Endangered Species Act Section 7 Consultation with the National Marine Fisheries Service (NMFS) for
Oyster Creek Nuclear Generating Station Shutdown and Decommissioning

Docket No. 50-219; License No. DPR-16

Responses to the NMFS's May 24, 2019, Additional Information Requests

June 11, 2019

Figure 1. Location of Barge Landing on Oyster Creek Site

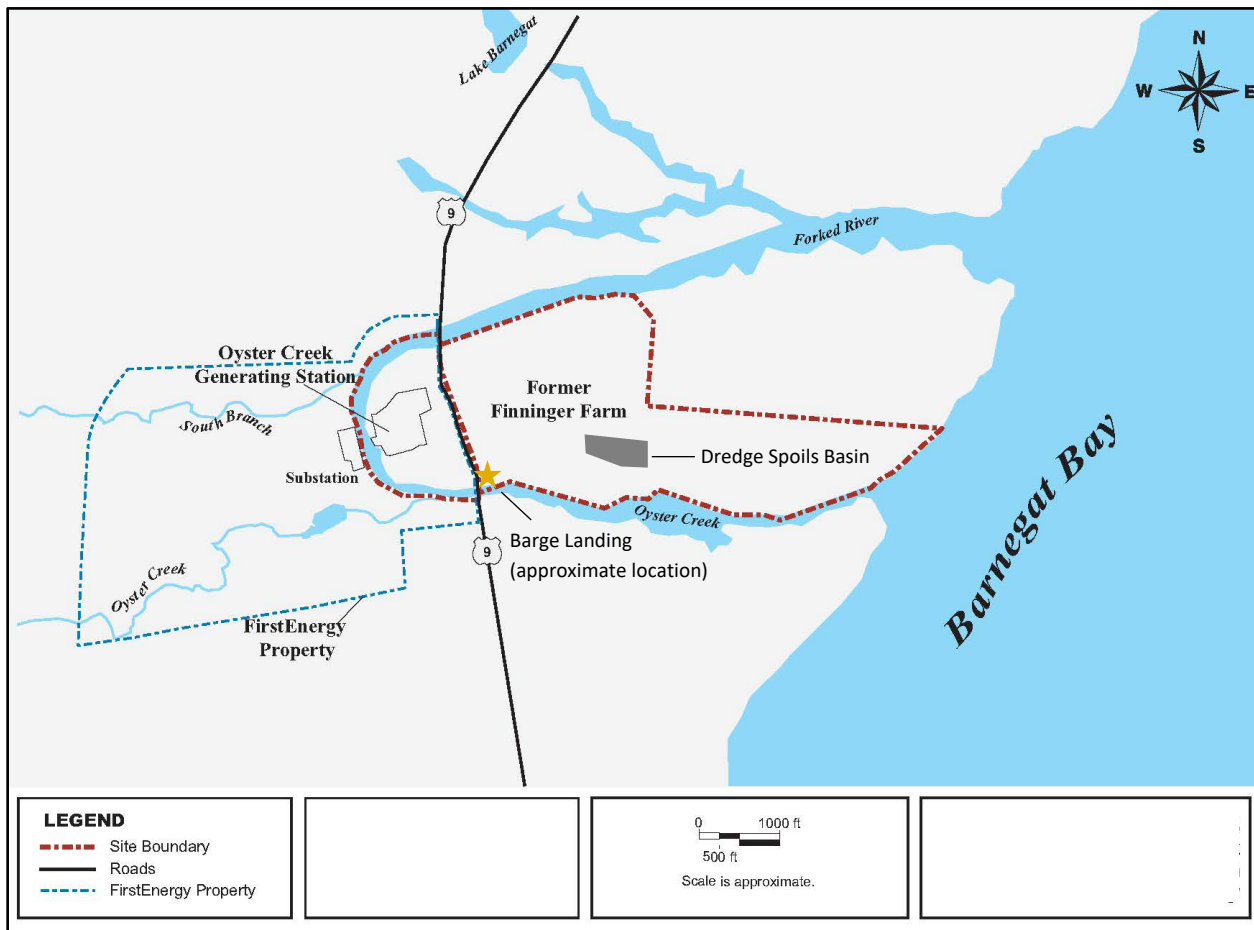
- 3. You and Exelon note that dredging may be necessary to facilitate the movement of plant components off site via barge. These activities will need to be considered in the reinitiation. It is my understanding that dredging has occurred in the area previously. It may be reasonable for the purposes of the section 7 consultation to assume that past dredging practices (i.e., dredge type) would be used for future dredging. We are not aware of any impingement or entrainment of sea turtles in a suction dredge. You would need to consider any impacts to sea turtle forage and other habitat features. I can provide you with an example of a dredge analysis if that would be helpful. Similarly, because vessel strike is a concern for sea turtles, you will need to consider effects of an increase in vessel traffic (i.e, the barges). I've attached a copy of the consultation we did for the North Anna project that considered use of a temporary offloading facility and may be helpful to you.**

During the decommissioning period, Exelon (2018b) anticipates that it will ship dismantled large plant components by barge from an existing barge landing at the north bank of Oyster Creek immediately east of U.S. Highway 9. The licensee has periodically used this barge landing during both the construction and operation periods to transport large components to and from the site. The barge landing contains no permanently installed equipment or infrastructure, and Exelon anticipates that none would be needed to support barge traffic and loading associated with decommissioning. In connection with barge traffic, Exelon (2018b) anticipates that dredging in Oyster Creek between the barge landing and Barnegat Bay to an unknown depth could be required to provide enough depth for barge vessels to pass. Dredging may also be required in Barnegat Bay itself to allow passage of loaded barges between the mouth of Oyster Creek and Barnegat Inlet. Any dredging would require Exelon to obtain U.S. Army Corps of Engineers and appropriate New Jersey Department of Environmental Protection, Division of Land Use Regulation, permits. Exelon (2018b) would dispose of dredge spoils in an existing State of New Jersey dredge spoils basin on Exelon property east of the barge landing. Figure 1 below depicts the location of the barge landing and the dredge spoils basin within the former Finnigan Farm portion of the Oyster Creek site.

For the purposes of its analysis, the NRC staff assumes that barge vessel traffic would only occur during the large component removal phase of the decommissioning period. Exelon (2018b) currently anticipates that this phase would require one year to complete and would occur between June 2075 and June 2076.² The NRC staff conservatively assumes that large component removal would necessitate up to four barge loads such that barge vessel traffic would occur quarterly for the one-year large component removal phase. The NRC staff also conservatively assumes that prior to this phase of decommissioning, dredging would be required to allow for vessel traffic. The NRC staff assumes that dredging would take place in the first half of 2075 and that dredging would only occur once because large component removal would be completed within a year. Based on information on past dredging within the area, one year is not enough time for sediment to build up to a degree that would necessitate further dredging. Finally, the NRC staff assumes that cutterhead
